UNTIL SUCH TIME AS THESE DRAWINGS ARE APPROVED BY THE APPROPRIATE REVIEWING AGENCIES, OR ENGINEERING APPROVES THEIR USES DESIGNATED BY WRITTEN AUTHORIZATION.	
PREPARED FOR	ROI PROPERTY GROUP, LLC 2495 RIGDON STREET NAPA, CALIFORNIA (707) 365-6891 BRADY WILLIAMS
	 J.R. ENGINEERING A Westman Company Centennial 303-740-9888 • Colorado Springs 719-583-2583 Fort Collins 970-491-9888 • www.jrengineering.com
BY	DATE
No.	REVISION
H-SCALE	1"=200'
V-SCALE	N/A
DATE	1/2/21
DESIGNED BY	AHC
DRAWN BY	AHC
CHECKED BY	
SADDLEHORN RANCH - FILING 2	
HORIZONTAL CONTROL PLAN	
SHEET	5 OF 40
JOB NO.	25142.04

SADDLEHORN RANCH -
 FILING 2
 STREET IMPROVEMENT PLAN
 AND PROFILE

A2 CULVERT - PLAN

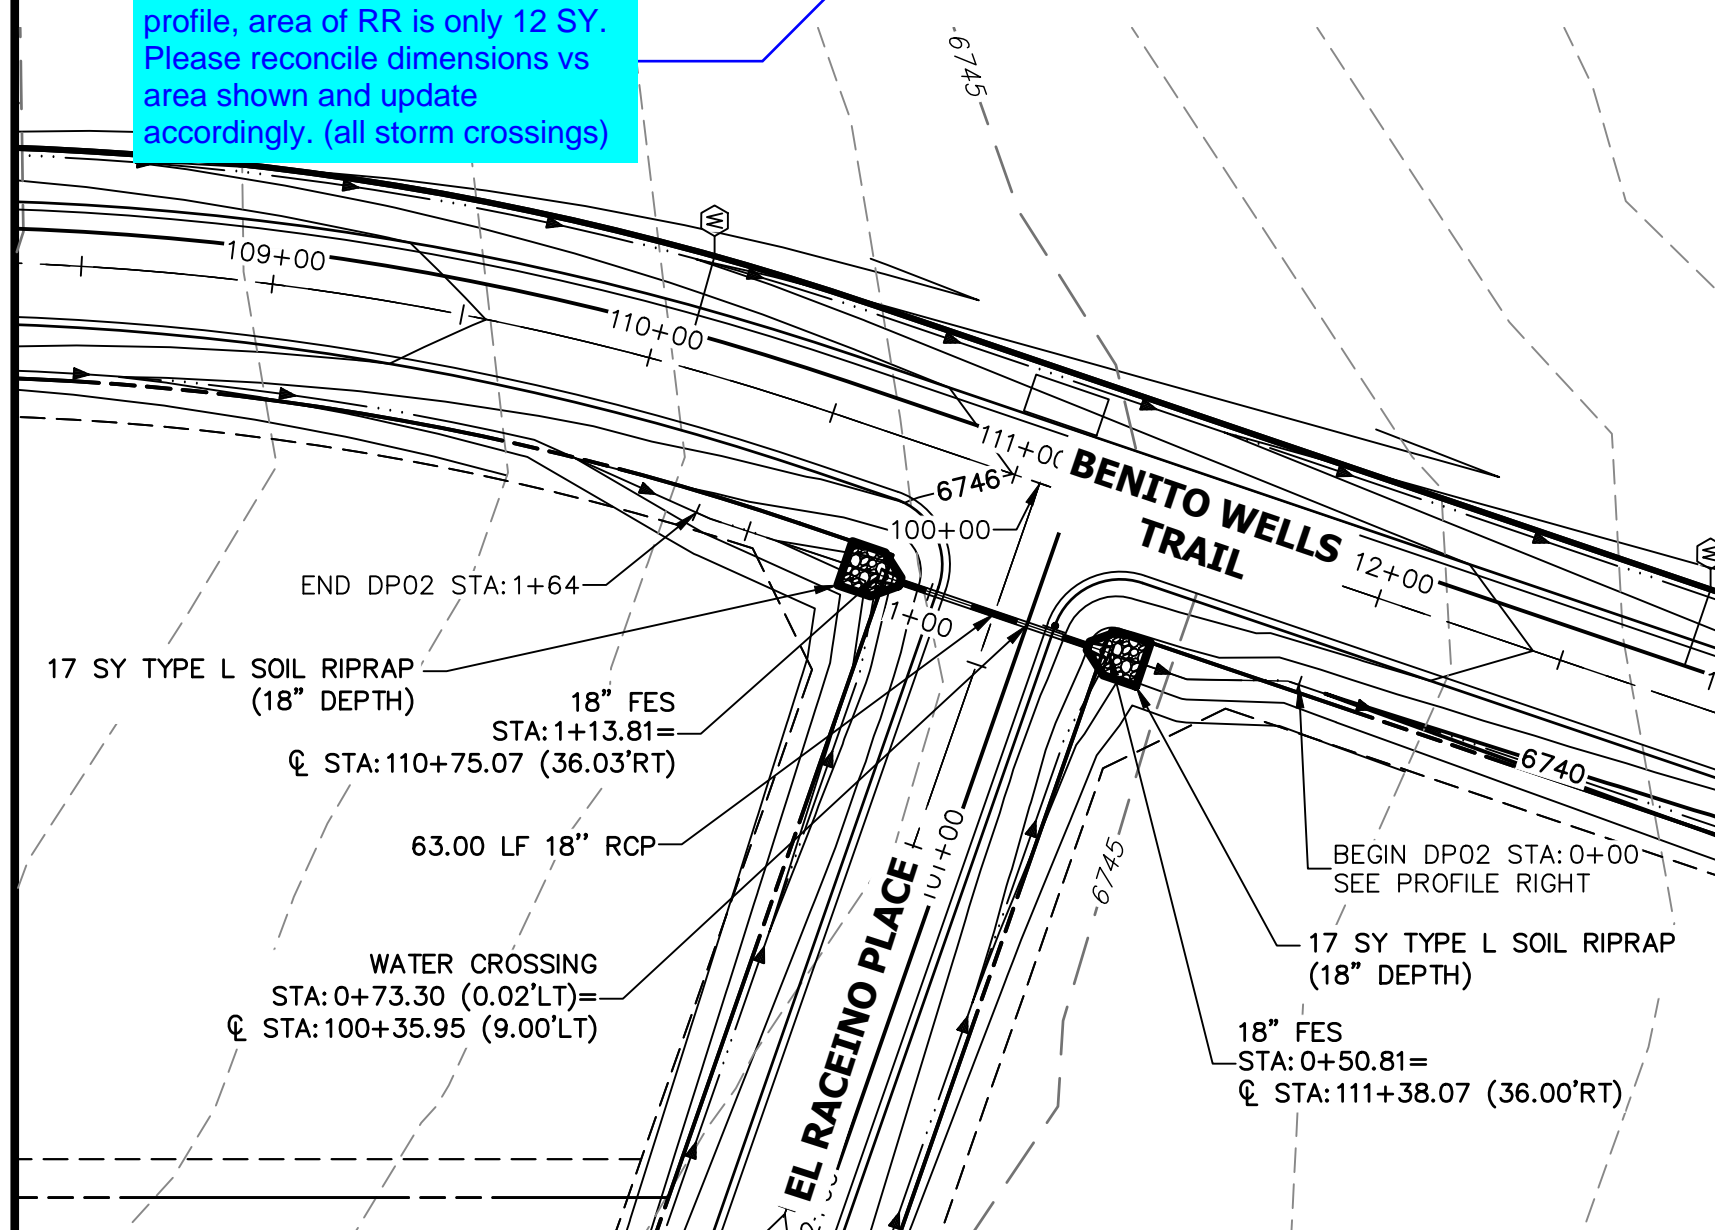
Based on dimensions shown in profile, area of RR is only 12 SY. Please reconcile dimensions vs area shown and update accordingly. (all storm crossings)

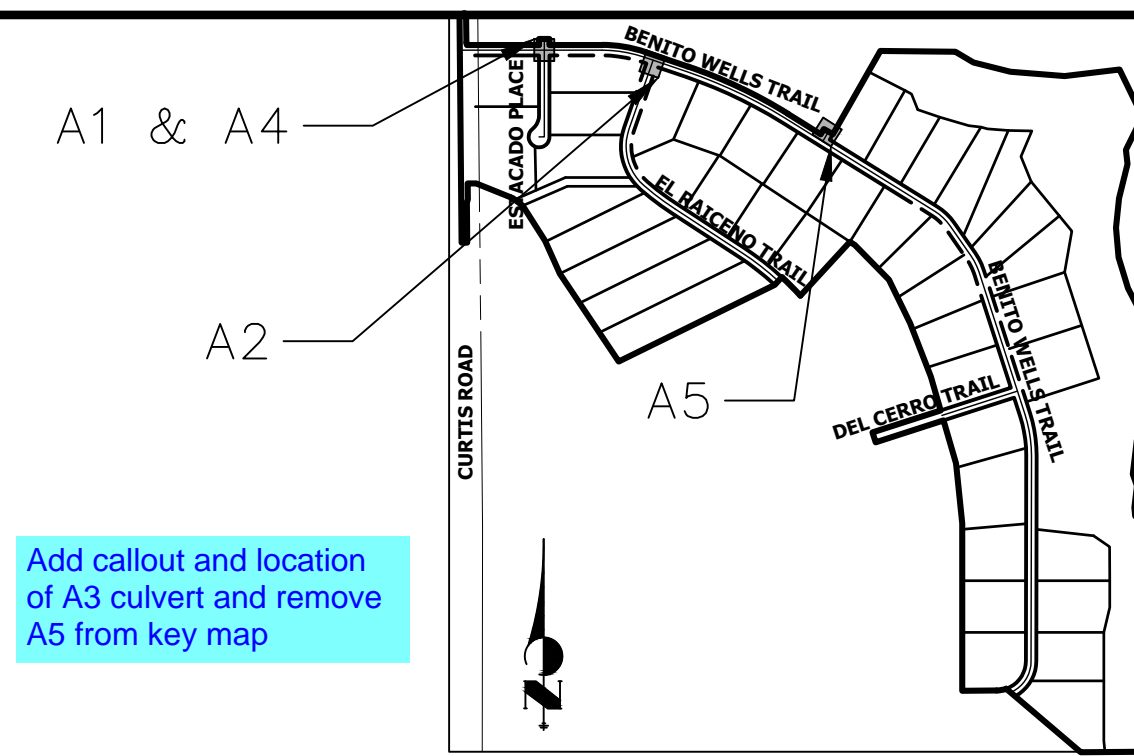
Add callout and location of A3 culvert and remove A5 from key map
